Closure Plan, Rev. 2
Tanners Creek Fly Ash Pond

**Facility Name: Tanners Creek Plant
Fly Ash Pond Complex**

**RE: Tanners Creek Fly Ash Pond Capping/Closure Plan
Response to Comments**

Reference: Responses to IDEM 5/10/18 RAI
Fly Ash Pond Closure, Tanners Creek

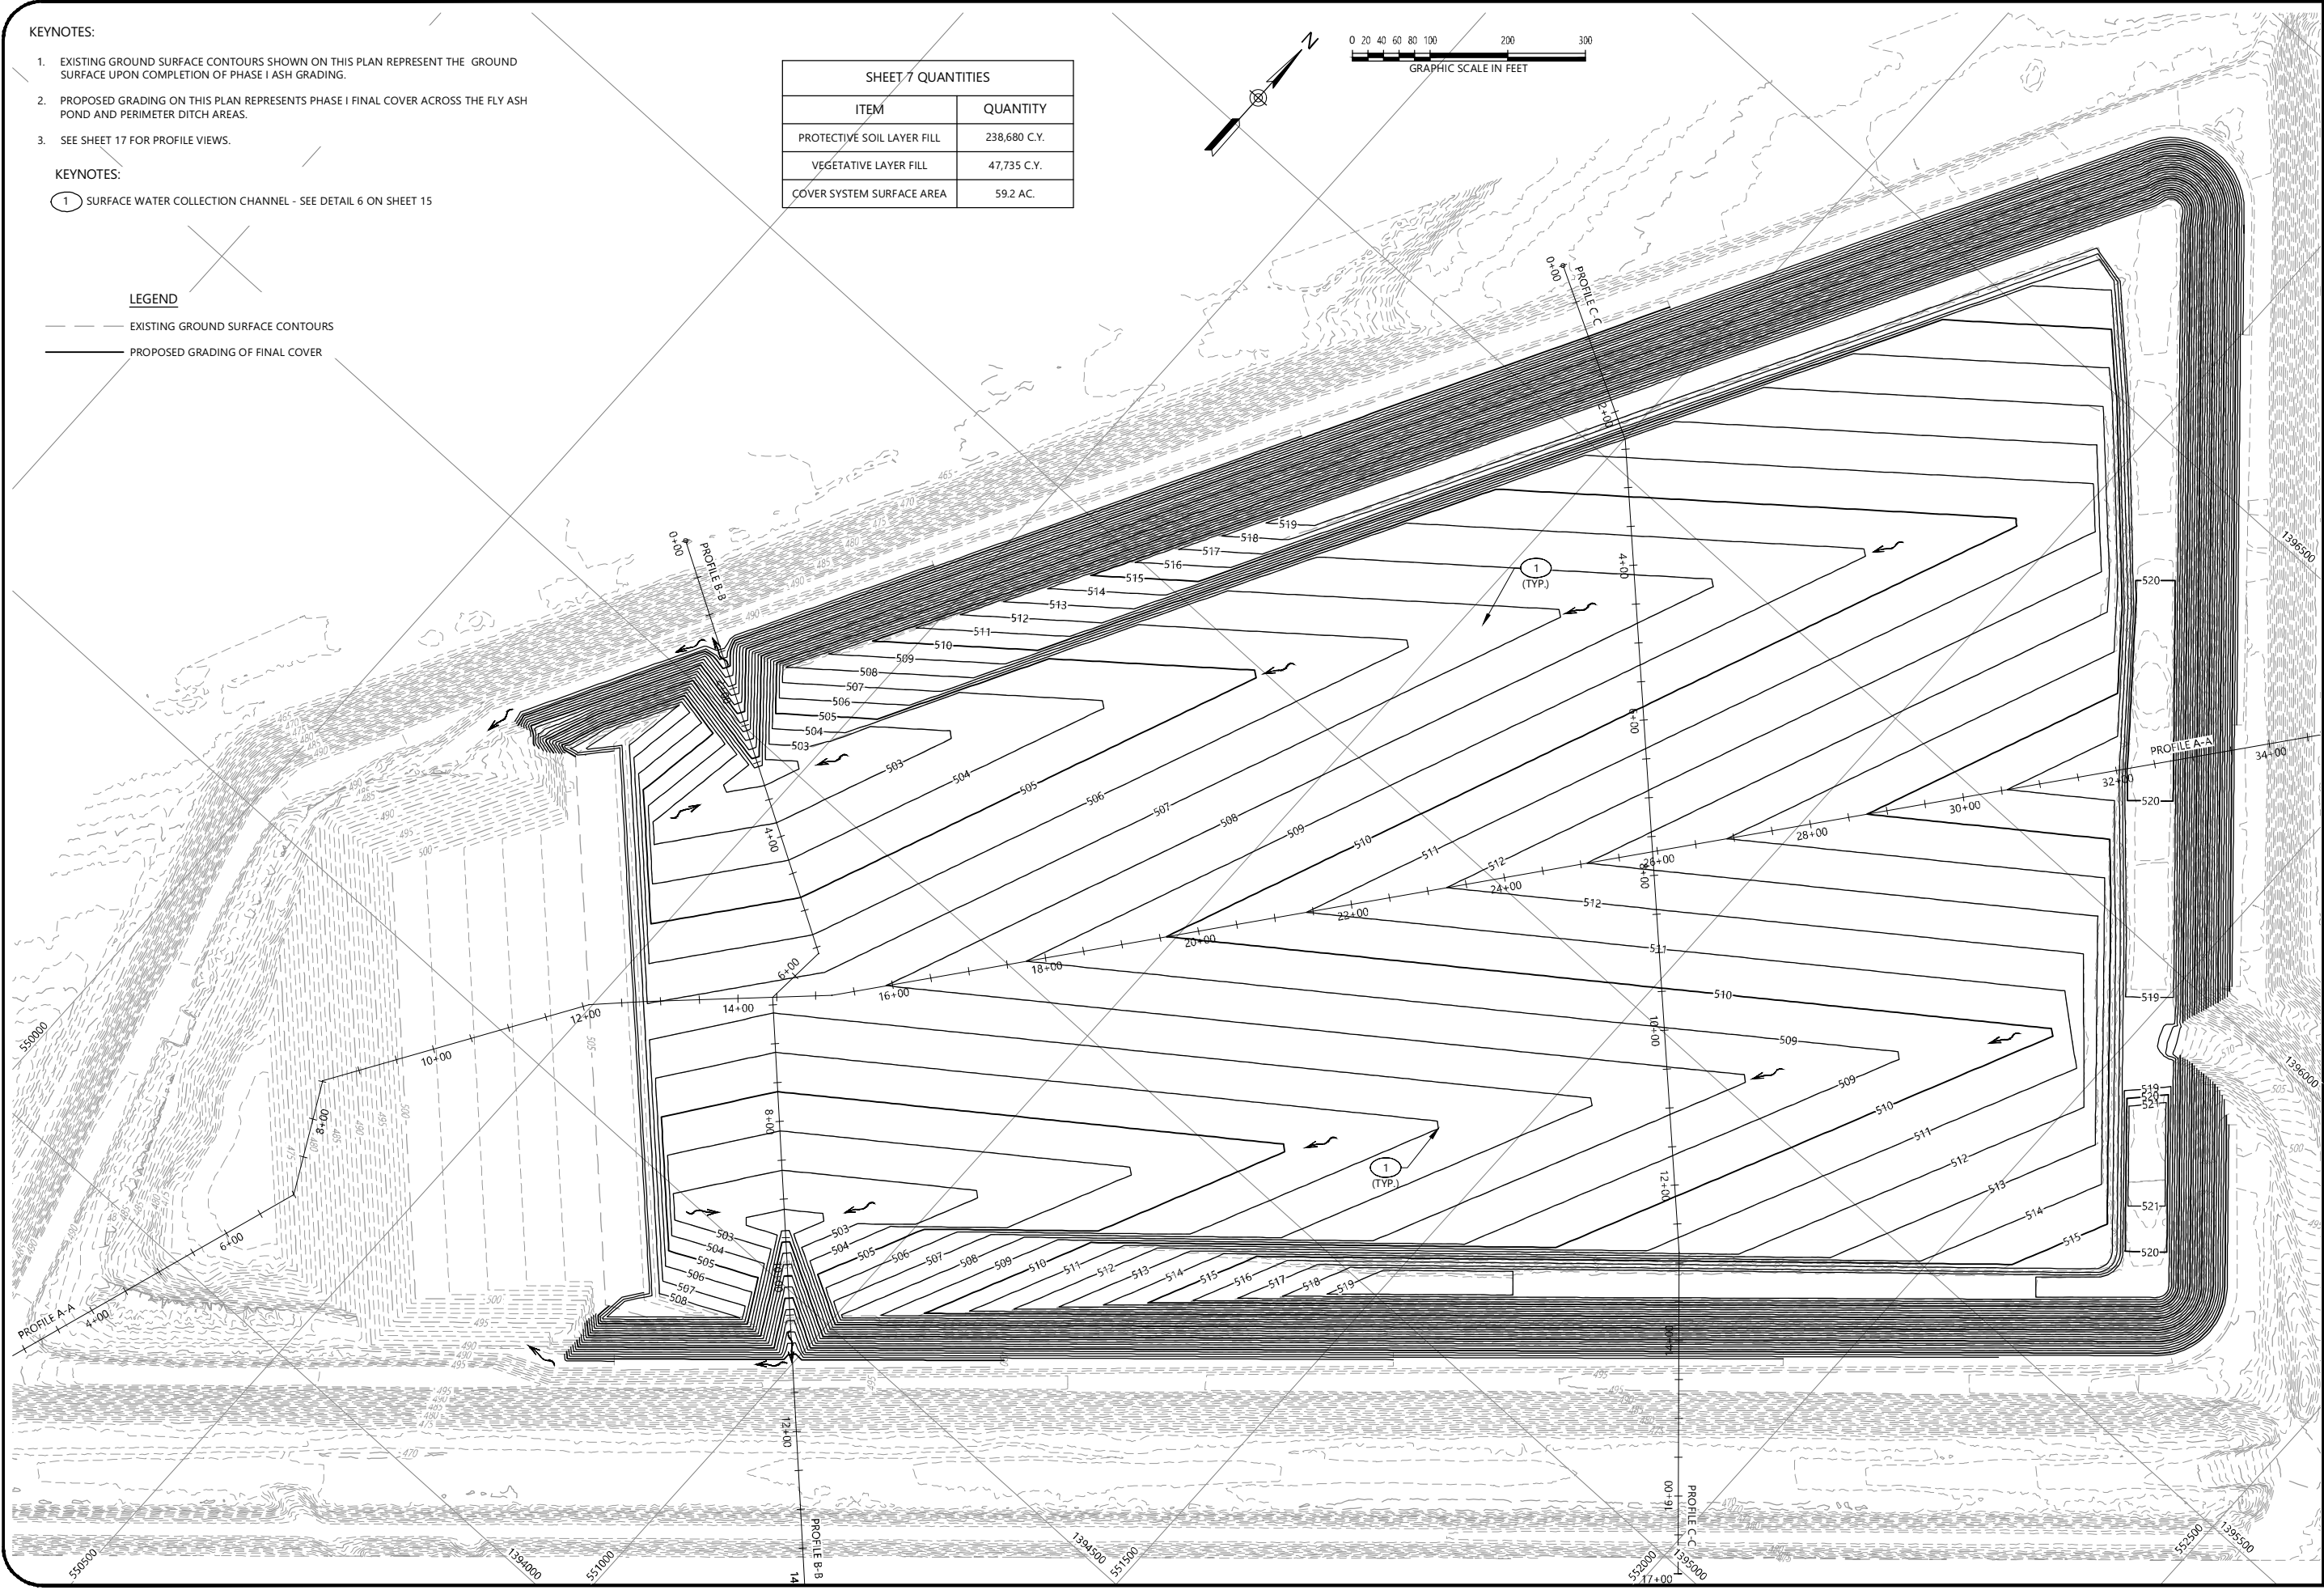
1. In response to IDEM's comment regarding the cover system design, you modified the soil cover to include a six-inch vegetative layer over 30 inches of protective soil. The typical sections (Sheet 13), final cover details (Detail 1 on Sheet 14), and closure cost estimate have been modified for 36-inch final cover, but neither the Ash Grading Plan nor the Final Cover System Plan was changed. Please modify these drawings to reflect the 36-inch soil cover, and update the soil and/or ash cut-fill volume on the drawings and in the report (Table 5-1 and Table 5-2). Please verify the surface water control design will accommodate the 36-inch final cover.

Grading Plans – Proposed grades on Drawings 7 and 9 have been modified to reflect the 36-inch cover system thickness. Additionally, the background topographic maps on Drawings 8, 9, and 10 have been modified to reflect the 36-inch cover system.
